2020 Paving Project(s) – Phase II

PROJECT NUMBER: 0916-8216

Heritage Elementary School

ADDENDUM NO. 1

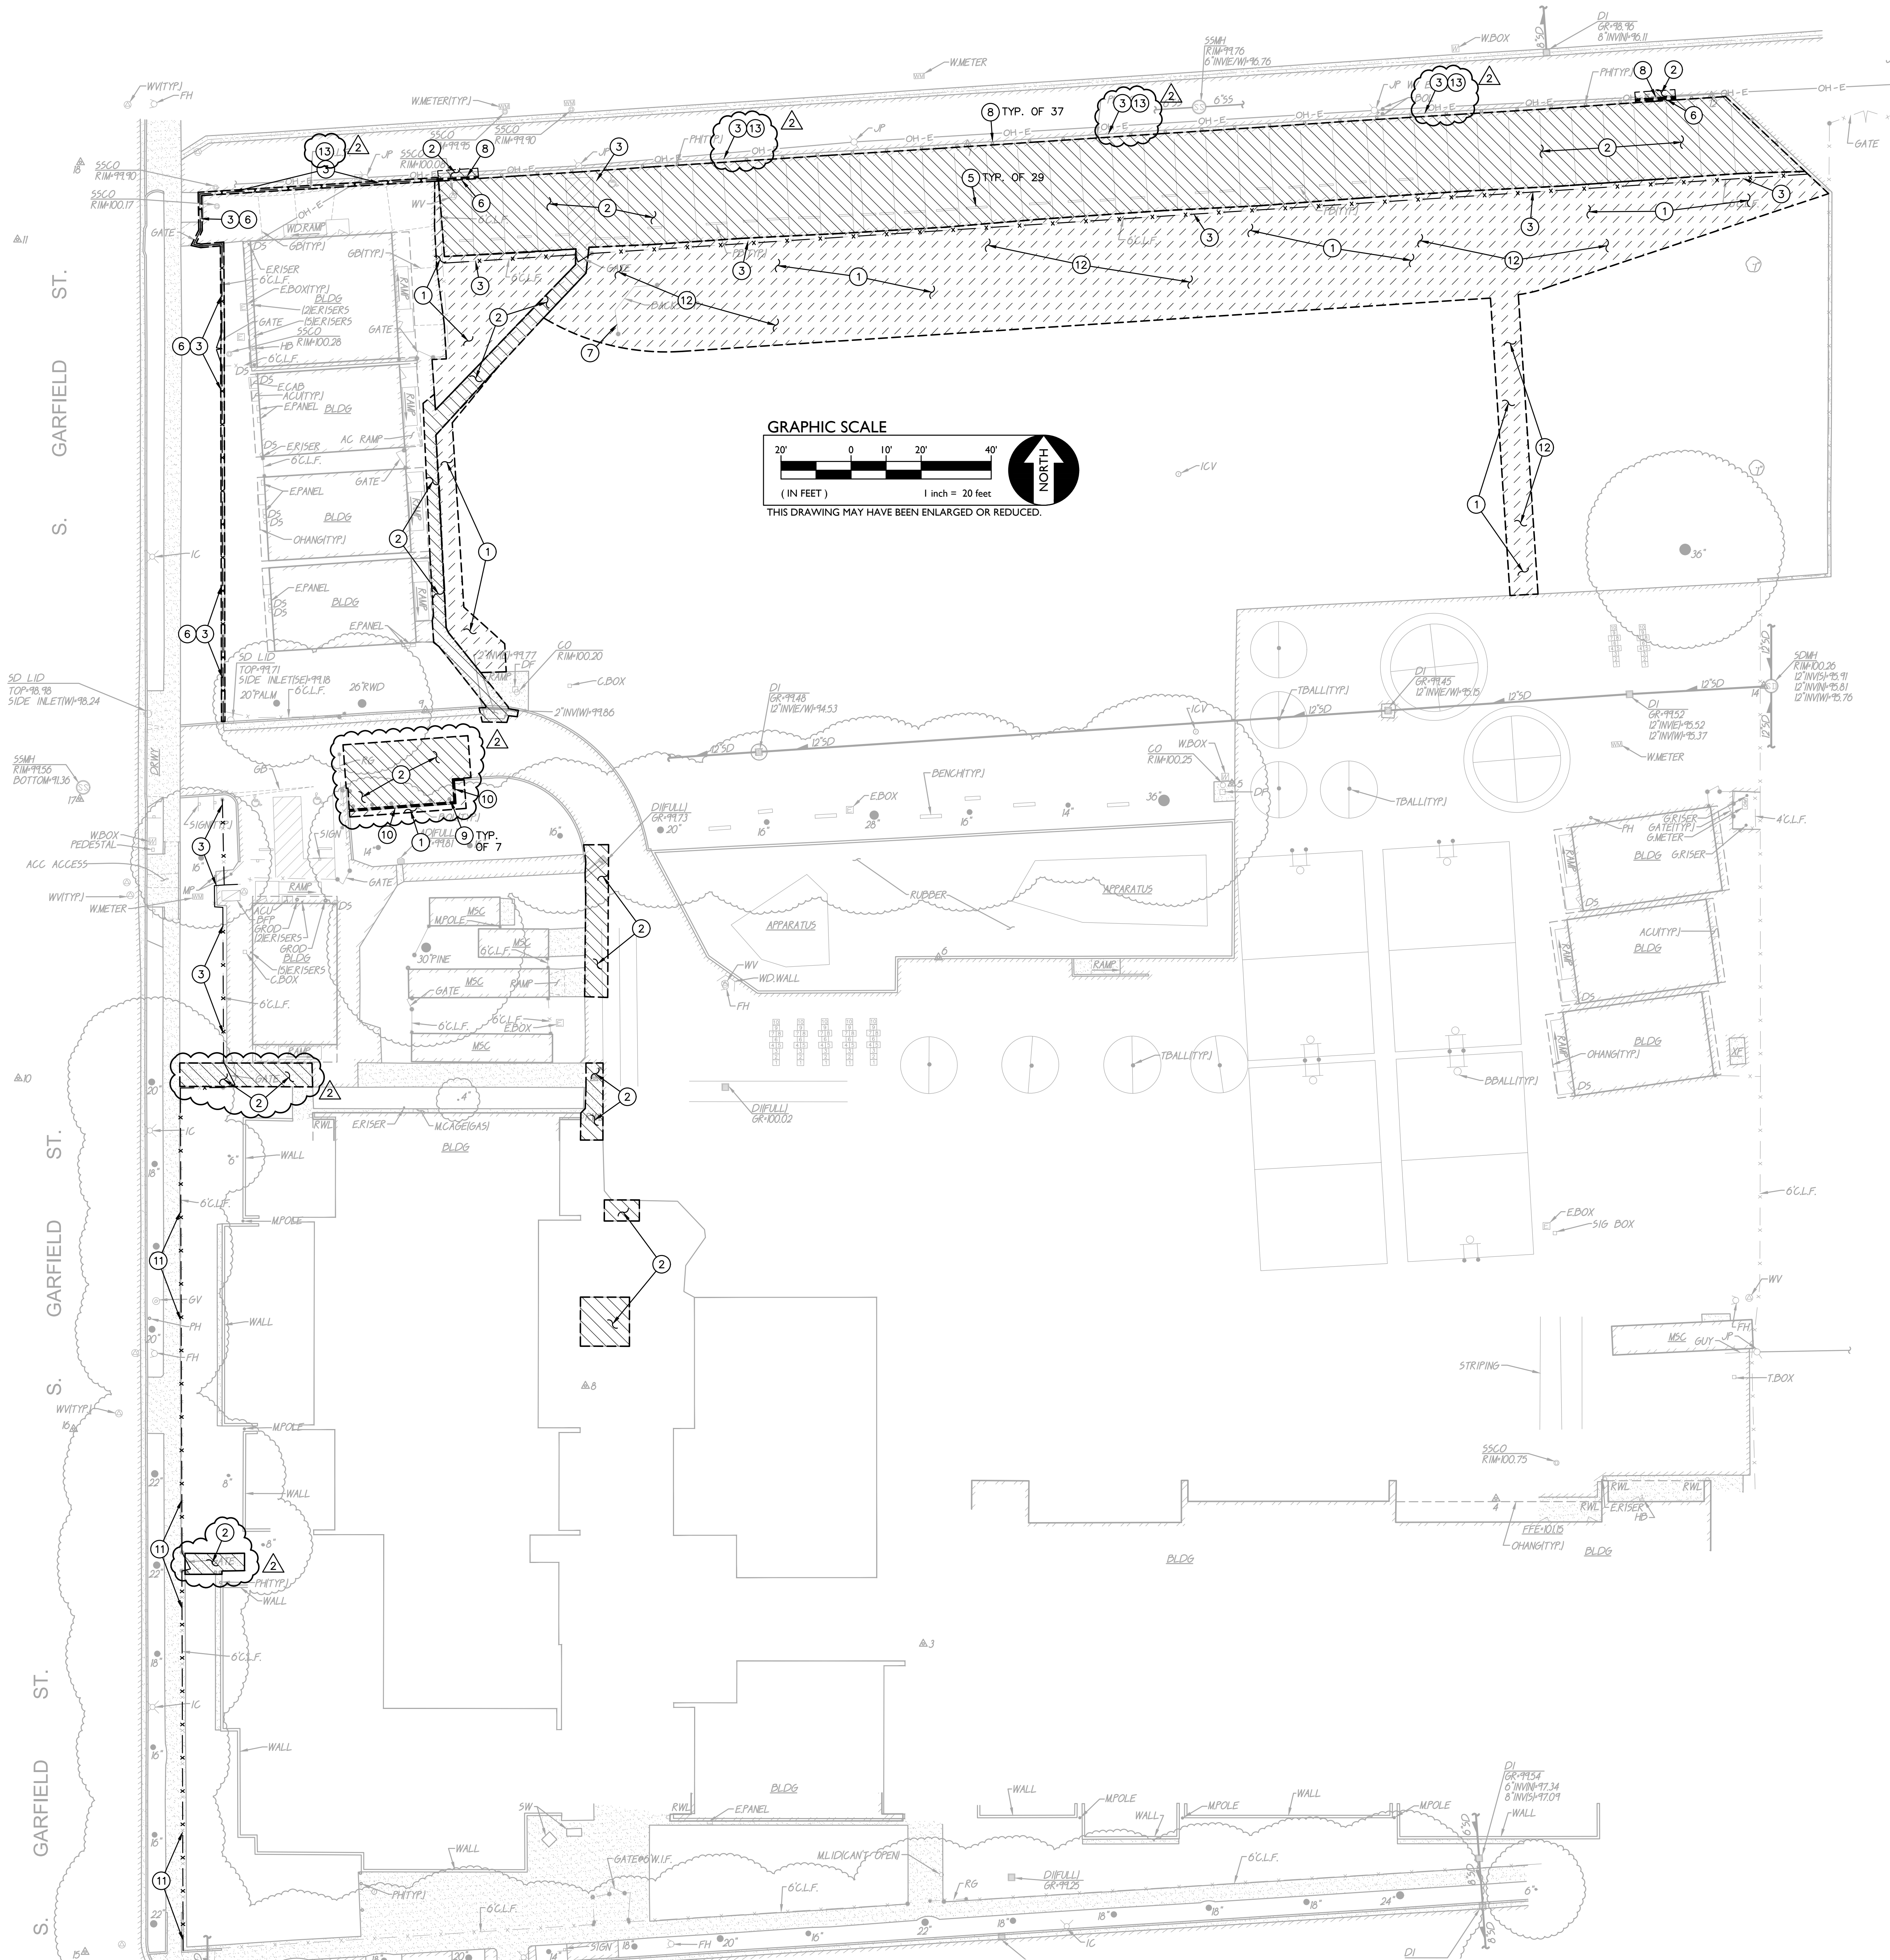
- 1.3 Refer to Drawing Sheet C1.1 Demolition Plan. Replace in its entirety with Drawing Sheet C1.1 Demolition Plan, dated 01/27/2020.
- 1.4 Refer to Drawing Sheet C3.1 Paving Plan. Replace in its entirety with Drawing Sheet C3.1 Paving Plan, dated 01/27/2020.
- 1.5 Insert Drawing Sheet E100 Partial Site Plan – Electrical, dated 01/24/2020.

- 1.9 **Question:** It was noted at the job walk that the entire section of concrete which has the cut off posts in the concrete strip is to be removed. However per sheet C1.1 note 8 states remove posts and associated footing "typ of 37". C1.1 also only shows two spots where the demolition limit encroaches on this area. Please clarify what is to be removed at this location.

Response: No
- 1.12 **Question:** There are some areas on the demo plan that show us removing asphalt next to some post holes but are not shown to be paved back on any sheet. Is this the intent?

Response: Refer to Drawing Sheet C1.1, Note 12.
- 1.14 **Question:** The trash enclosure is shown to be poured neat against the existing asphalt. Is this the intent or do you want a 1-2' strip of asphalt patch back to help with the transition?

Response: Refer to Drawing Sheet C1.1 Demolition Plan, dated 01/27/2020 for clarification.
- 1.10 **Question:** For bidding purposes are we to assume standard colors for the CMU? And do we assume smooth or split face?

Response: Refer to Drawing Sheet C1.1 Demolition Plan, dated 01/27/2020.
- 1.13 **Question:** Is the contractor responsible for reconstructing the irrigation or will the school district do it? If the contractor is responsible for the cut, cap, and moving of said irrigation can we have an as-built pan of sort so we can see the extent of the work?

C3.1

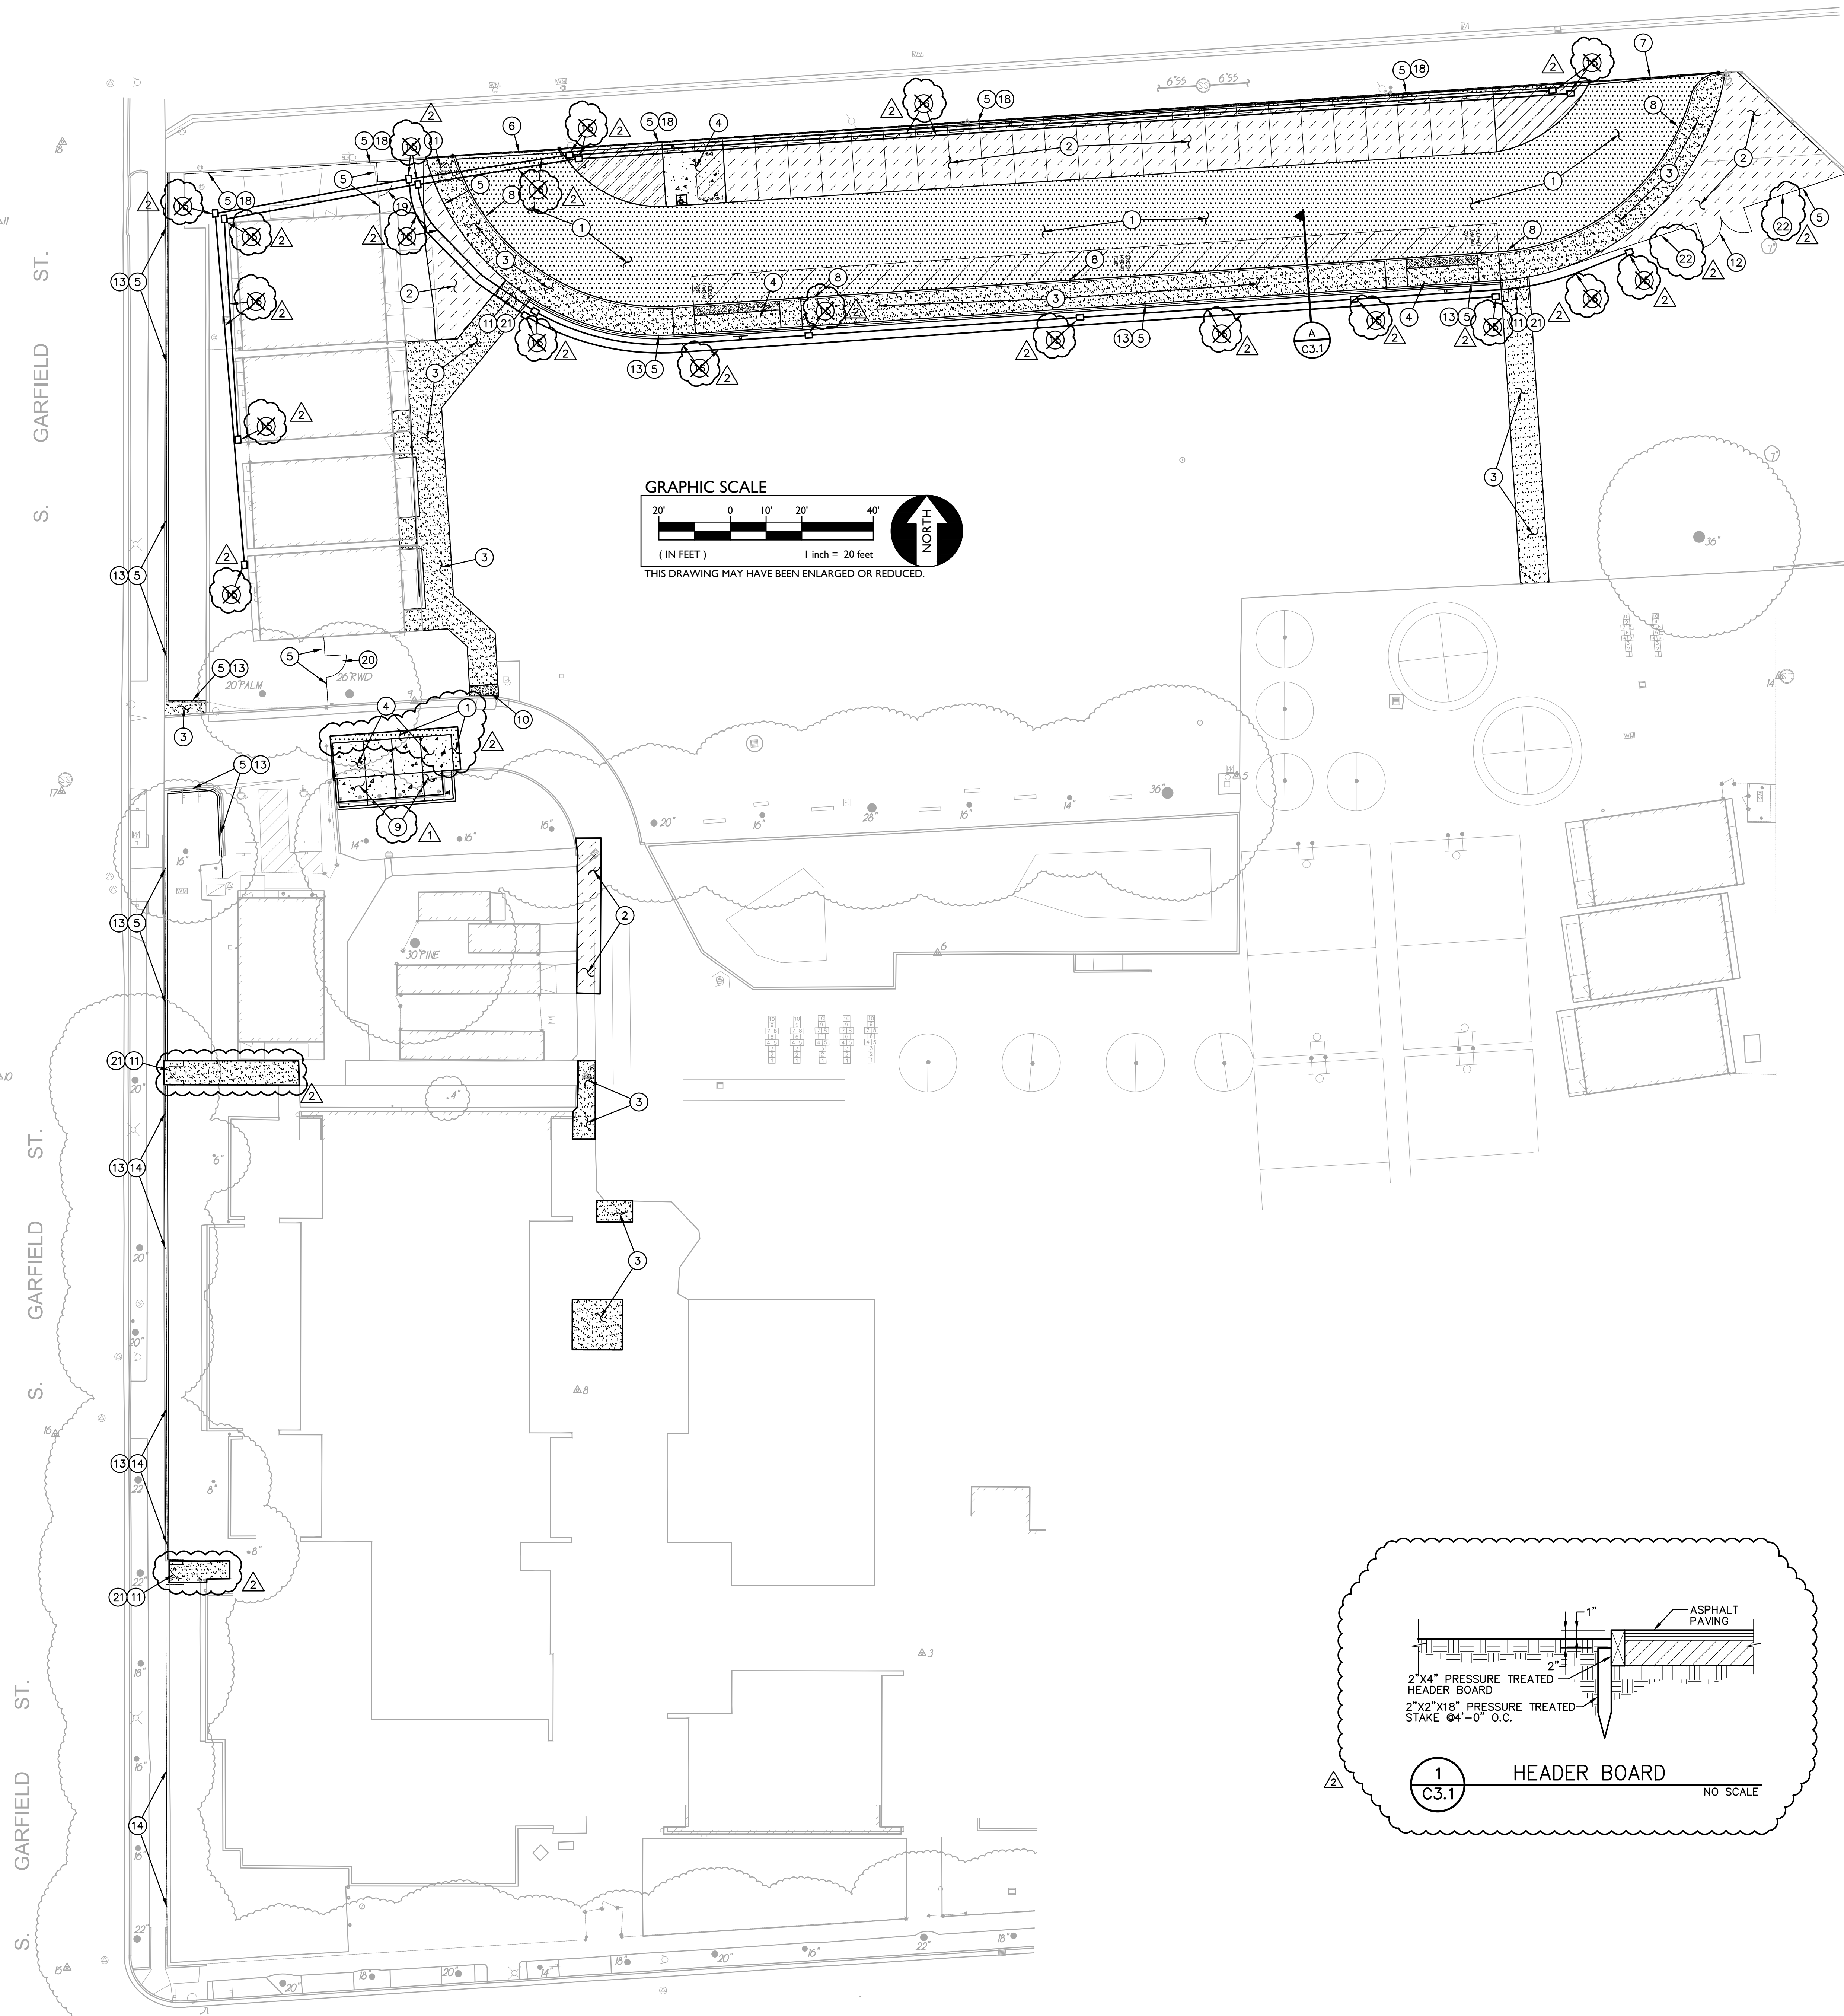
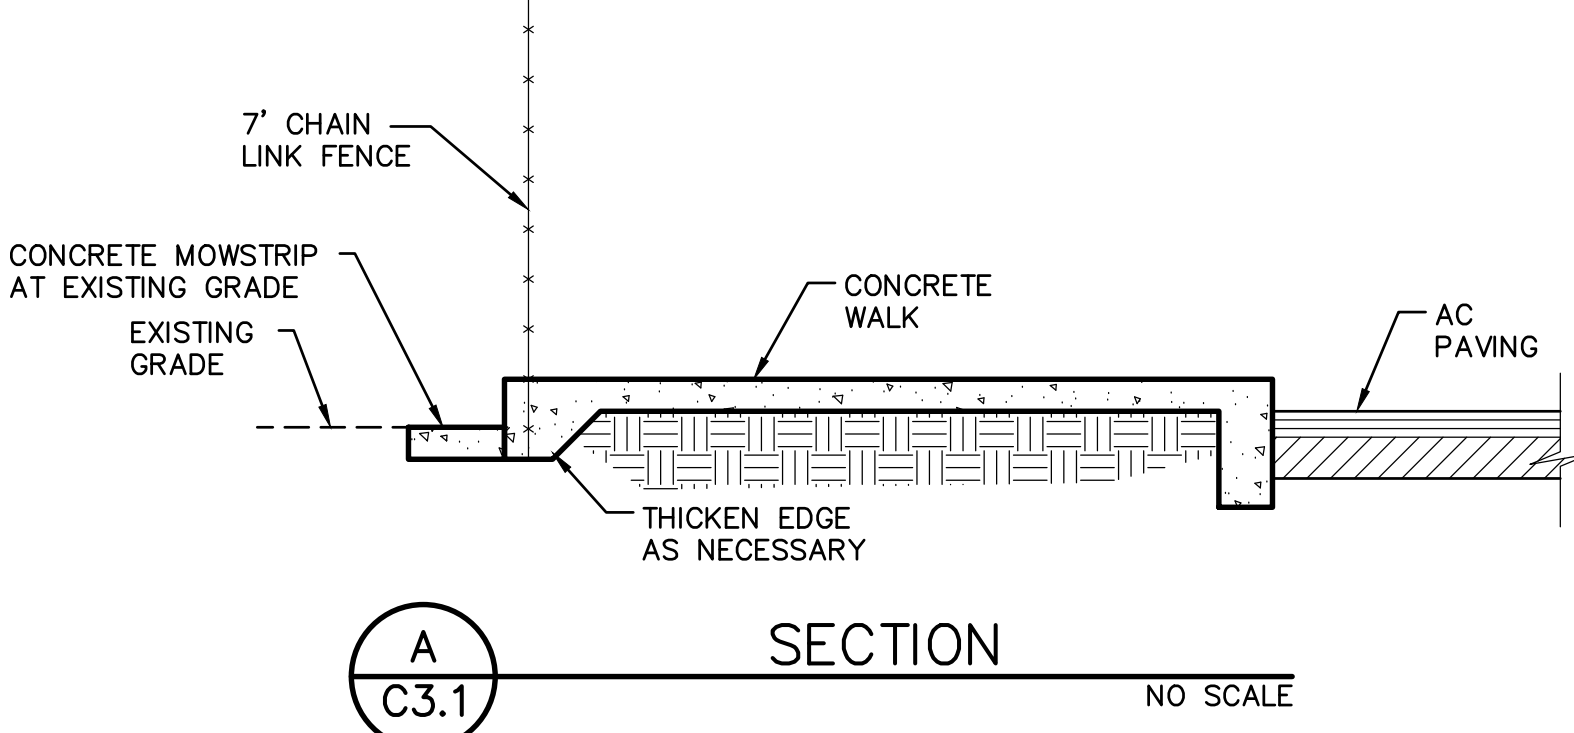
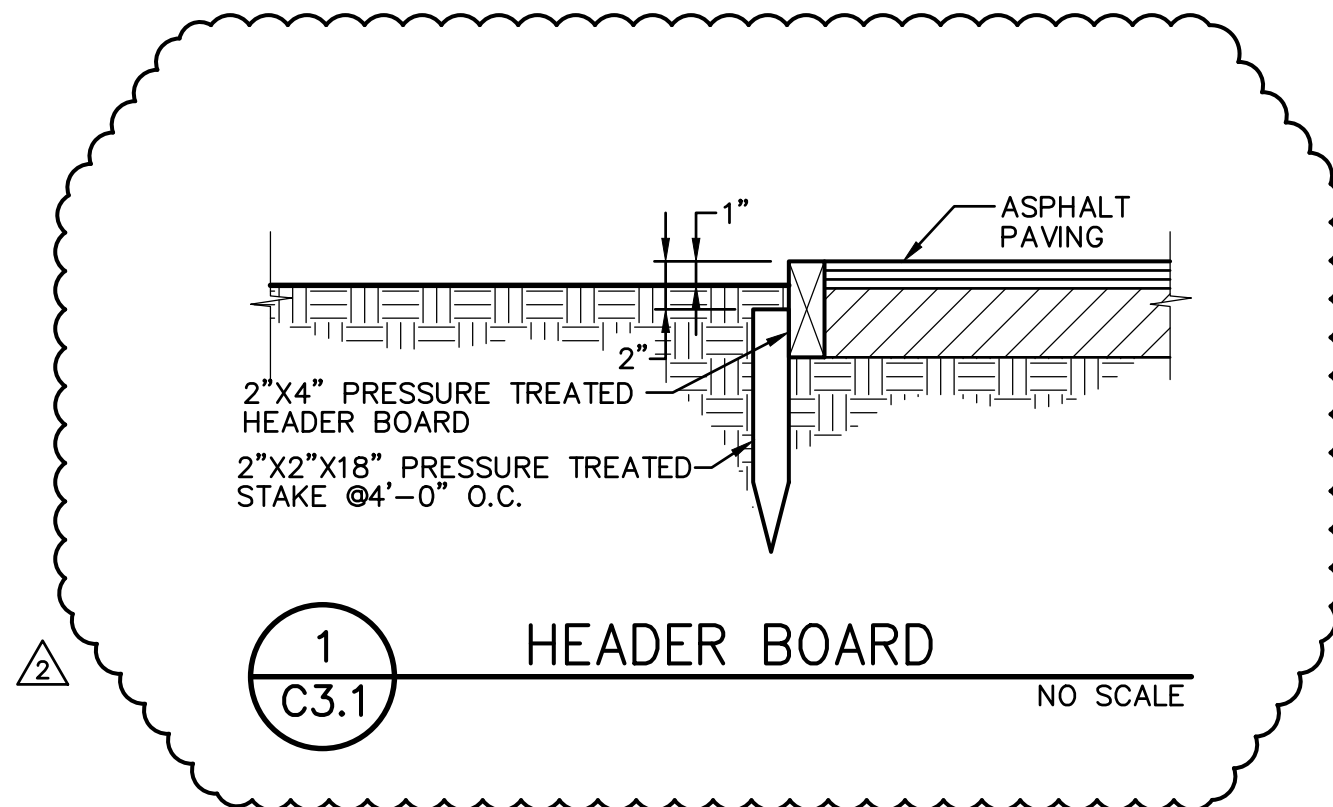
Response: Refer to Drawing Sheet C3.1 Paving Plan, dated 01/27/2020.
- 1.15 **Question:** What work is to happen at the areas calling for a 60" min landing at the gate entrances on sheet C3.1?

- 1.22 **Question:** Does there need to be a header board where asphalt is directly adjacent to landscape areas? If so what type and size?
Response: Yes. Refer to Drawing Sheet C3.1 - Paving Plan, dated 01/27/2020 for clarification.

- 1.23 **Question:** Note 16 on sheet C3.1 calls for 2 conduits but is pointing to two different lines. So are there 2 conduits or 4 conduits running to the pull boxes?

Response: Delete all the conduit notes on sheet C3.1. Refer to Drawing Sheet C1.1 Demolition Plan, dated 01/27/2020. Also refer to Drawing Sheet E100 Partial Site Plan – Electrical, dated 01/24/20 for clarification.

Response: Refer to Addendum 1 Drawing Sheet C3.1 Paving Plan, dated 01/27/2020.
- 1.16 **Question:** Will temp fence be required around the project?
Response: Yes.
